RONJA

Reducing minimum communication distance

Change in 10M Receiver or Inferno Receiver:

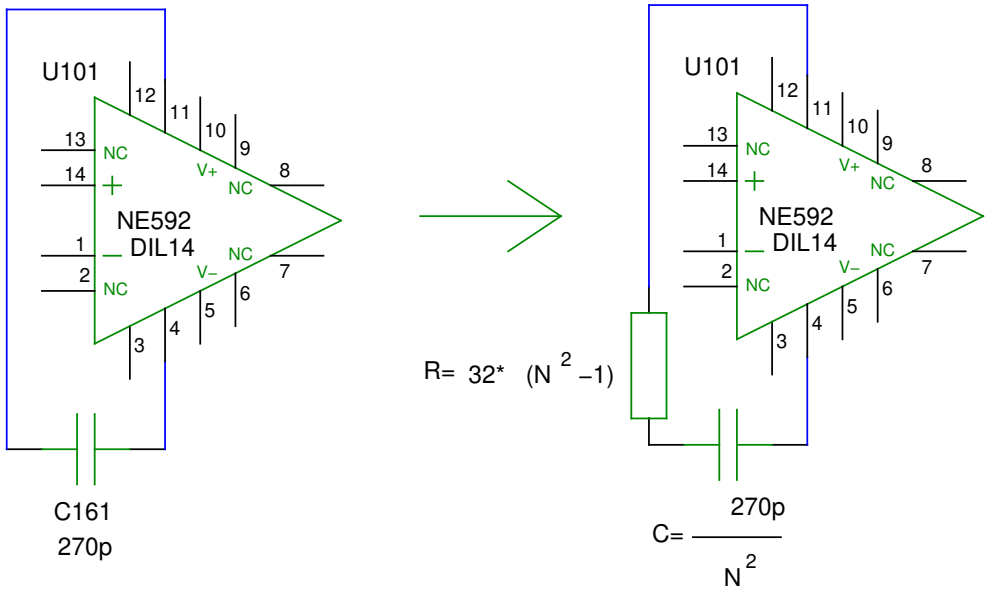
N=how many times we want to reduce minimum distance.

Example: we want to reduce minimum distance

from 90m to 45m. Then N=2.
